# Access Compliance Report

## Public Rights-of-Way

Intersection ID: 9408	Main Street: E_SUGAR_CREEK_RD	Cross Street: RALEIGH_ST	Location:	N
ADA ID: BB79558EC3F9	Ramp Type: Perp	Initial Pass/Fail: Fail	Overall Compliance: No	Severity Score: 12.5
Codes/Mitigation Info/Possible Solution		Field Measurements/Component Compliance

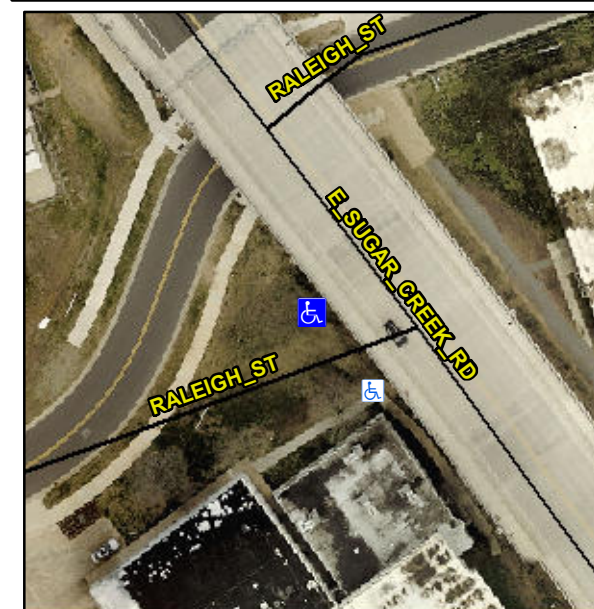
Compliance	Description	Data	Compliance	Description	Data
N/A	Ramp Length (in)	95.0	No	Ramp Slope (%)	8.8
Yes	Ramp Width (in)	83.0	Yes	Ramp XSlope (%)	0.3
N/A	Flare Type LT	N/A	N/A	Flare Type RT	N/A
N/A	Flare Slope LT (%)	N/A	N/A	Flare Slope RT (%)	N/A
N/A	Flare Traversable LT?	N/A	N/A	Flare Traversable RT?	N/A
N/A	Landing Length (in)	N/A	N/A	DWS Provided?	N/A
N/A	Landing Width (in)	N/A	N/A	DWS Contrast?	N/A
N/A	Landing Slope (%)	N/A	N/A	DWS Length (in)	N/A
N/A	Landing X Slope (%)	N/A	N/A	DWS Full Width?	N/A
N/A	Landing Curb? (Y/N)	N/A	N/A	DWS Offset (in)	N/A
N/A	Shared Landing?	N/A			
N/A	Gutter Ponding?	N/A	N/A	Gutter Slope (%)	N/A
N/A	Gutter Lip Ht (in)	N/A	N/A	Gutter X Slope (%)	N/A
N/A	Painted X Walk1?	No	N/A	Painted X Walk2?	N/A
	X Walk 1 Direction	To S		X Walk 2 Direction	N/A
N/A	X Walk 1 Width (in)	N/A	N/A	X Walk 2 Width (in)	N/A
	X Walk 1 Slope (%)	1.2		X Walk 2 Slope (%)	N/A
	X Walk 1 X Slope (%)	0.7		X Walk 2 X Slope (%)	N/A

**Remove & Replace Entire Ramp.**

**R304.2.2**
